# Technical Bulletin

**Product Line:** Bambi

**Subject:** Washers added to medium IDS assemblies

Figure 1 - Washer location

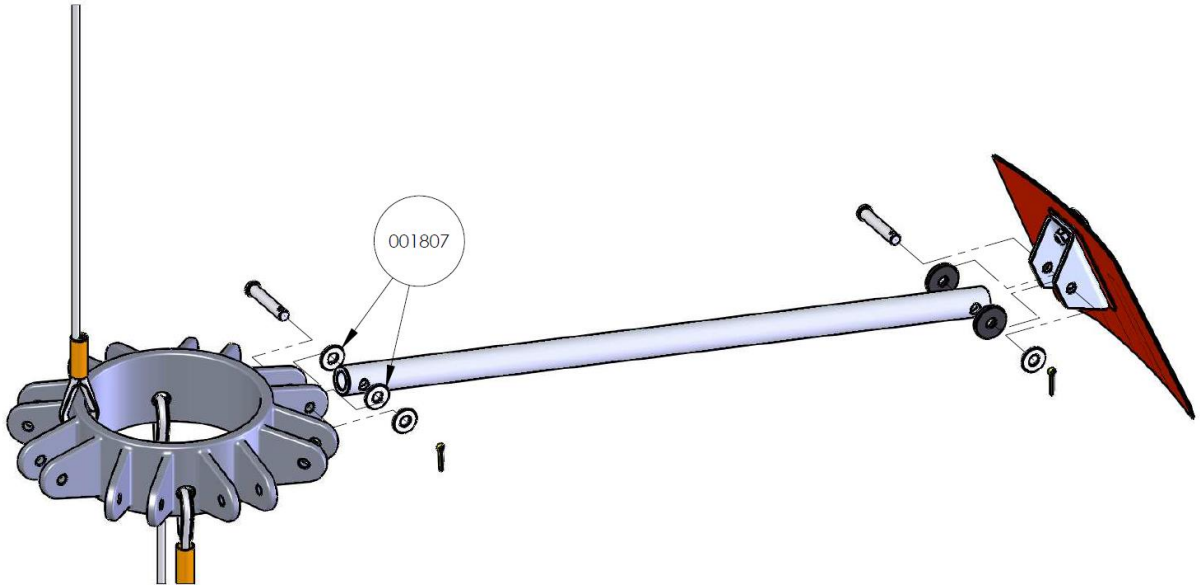
An issue has been reported where suspension lines were catching on the IDS hub when pulling out of a dip, which led to additional damage to the bucket shell. This happened because the suspension line became lodged between the spoke and the IDS hub. There is the potential for this to occur on all buckets using the medium size IDS hub. However, the spoke must be forced to one side to create enough clearance for the suspension lines to fit between the spoke, and the ear of the IDS hub.

To eliminate this issue, new medium IDS assemblies will include sixteen (16) 5/16" nylon washers (Part # 001807), which will center the spokes in the IDS hub and prevent the suspension lines from lodging themselves between the hub and the spoke.

Customers with medium IDS assemblies are advised to install washers between the spokes and the IDS hub to prevent this issue from occurring. See Figure 1 for reference.
